16 February 2022

SUBMISSION

Renotification D/2021/711
357 Glebe Point Road, Glebe NSW 2037
BIDURA HOUSE GROUP

Fig 1. Concept DA Drawing A1.6 Revision

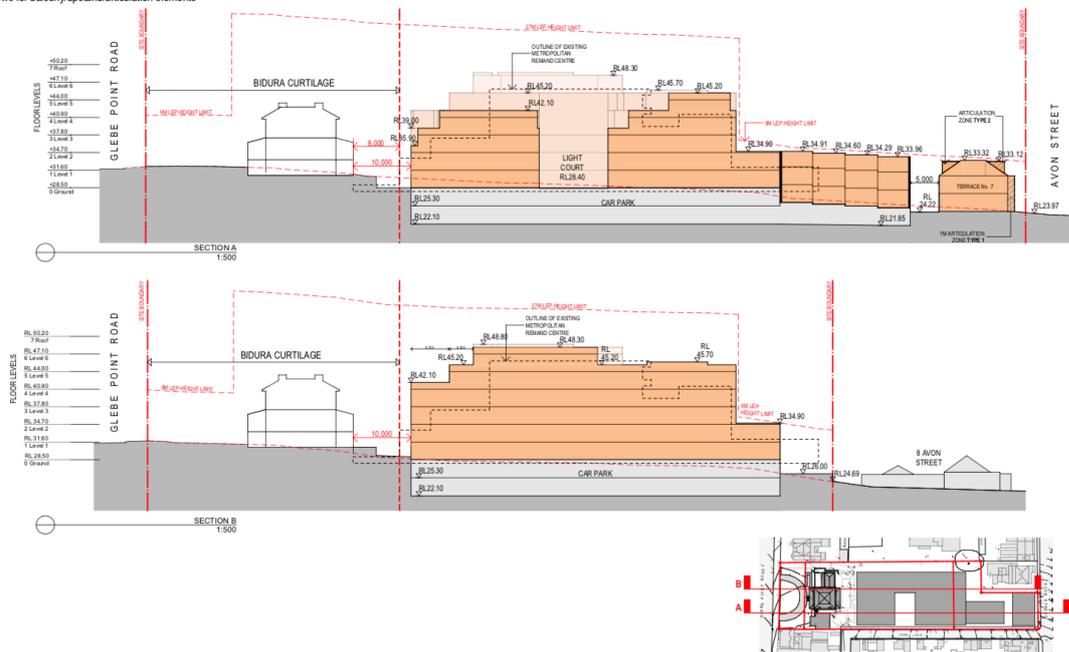
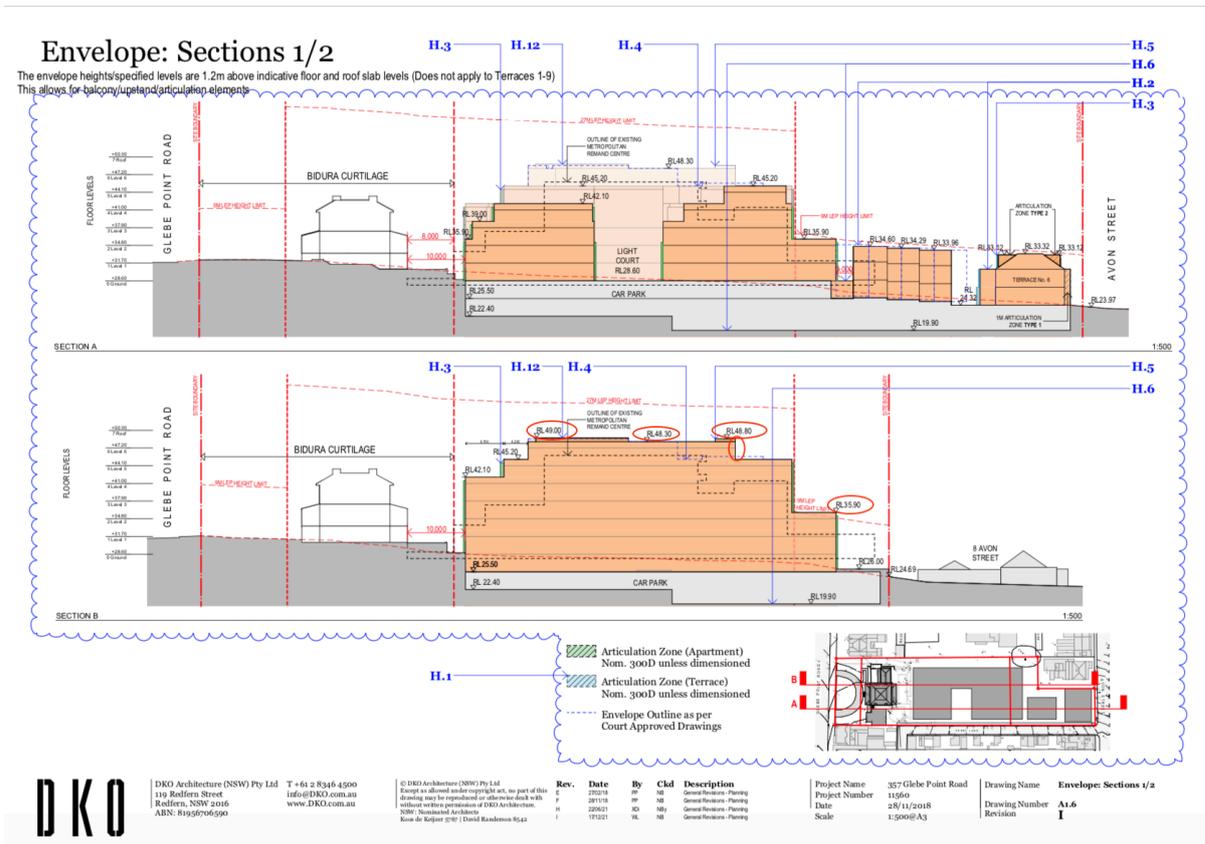
The amended documentation includes increases in building heights from the maximum heights approved in the Concept DA.

Fig 1 below represents the Concept DA buildings height envelope approved by the LEC.

Fig 2 below provides detail of the proposed raised heights as detailed on the corresponding drawing within the renotification documentation.

Note the levels detailed on Section plan B for the purposes of comparison.

The variations are circled in red on Section B of Fig 2.

The Concept DA provides for a maximum height of RL 48.80, whereas the amended documentation indicates a higher RL of 49.00.

The Concept DA provides for a maximum area and height of the Level 6 Penthouse of RL 48.30 whereas the amended documentation indicates a substantial extension of the Penthouse in an easterly direction and over to an area that was approved in the Concept DA at a maximum height of RL 45.70.

The building height of the Residential Flat Building (RFB) at the most easterly section over level 2 indicates an RL of 35.90 whereas the Concept DA indicates an RL of 34.90. It would appear that the northern end of this additional structural height will exceed the 9m height controls pursuant to the City of Sydney LEP 2012.

That the Concept DA heights be strictly adhered to and the Penthouse level be deleted entirely if additional heights to the building are required for building services and infrastructure or other reasons that are not apparent within the documentation.
